RE: Amended Preliminary Plan  
No. 1200020020E  
Chevy Chase Lake Block B

Thank you for the opportunity to review the Post Issuance submittal for the proposed (**Chevy Chase Lake – 14APMO01518**) located on MD 185 (mile point: 1.8) in Montgomery County. The State Highway Administration (SHA) has reviewed the plans and is pleased to respond.

**Re:** Preliminary Plan Amendment 12002020E and Proposed Site Plan Amendment 82016019D

Re: Response to Expressed Community Concerns  
Chevy Chase Lake Block B  
Preliminary Plan Amendment No. 12002020E &  
Site Plan Amendment No. 82016019D

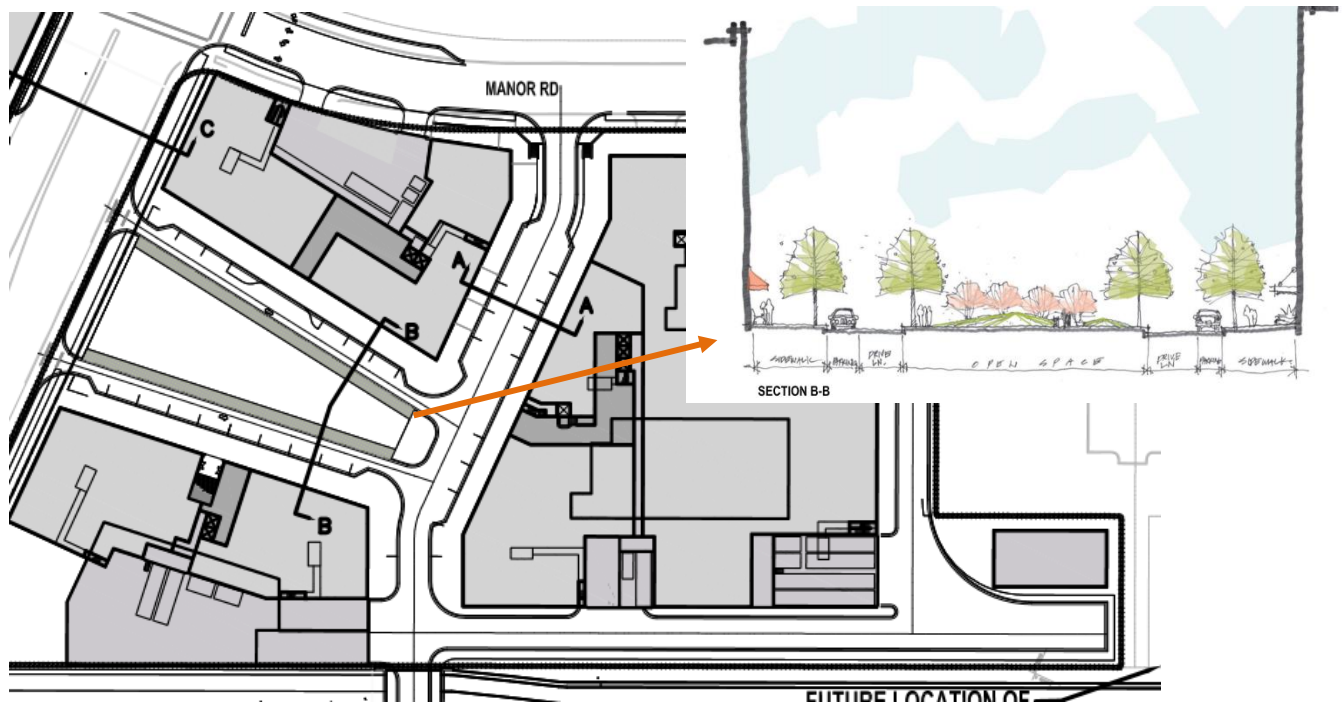
Some of the correspondence argues that the “the Sector Plan calls for a hardscaped plaza on the north side of the planned ‘Town Square.’” (Chevy Chase Hills Civic Association). There is no reference given to a specific page number for this assertion and we are not aware of any such recommendation in the Sector Plan. The Sector Plan “recommends a public open space of approximately ½-acre” on the Property but specifically allows the Planning Board to “determine its exact size, location and design through the development process.” (Sector Plan, Page 26). As mentioned, the approved Sketch Plan, which was found to be in substantial conformance with the Sector Plan, included the proposed one-way street – we do not recall any objections to the street expressed at that time. It was entirely the Applicant’s decision to replace the one-way street with a fire access lane in connection with the subsequent Preliminary and Site Plan applications. David T. Read’s contention that the private street, at this location, was “formally rejected by the Planning Board” is completely false.

The proposed Amendments continue to be in substantial conformance with the Sector Plan. The overall design and function of the Town Square will remain largely unchanged. Notably, as mentioned above, the overall size of the Town Square will be increased by approximately 2,500 square feet, resulting in an overall area of 19,500 square feet (as compared to 17,000 square feet previously approved). This additional area largely results from the conversion of Chaplin Place (to the south of the Town Square) into a one-way street (as opposed to two-way), which has allowed the Town Square to expand further to the south. As previously mentioned, this one-way vehicular circulation pattern around the Town Square is fully consistent with the circulation originally proposed by the Sketch Plan (*See* below for an excerpt from Sheet No. SK-9 of the Approved Sketch Plan).
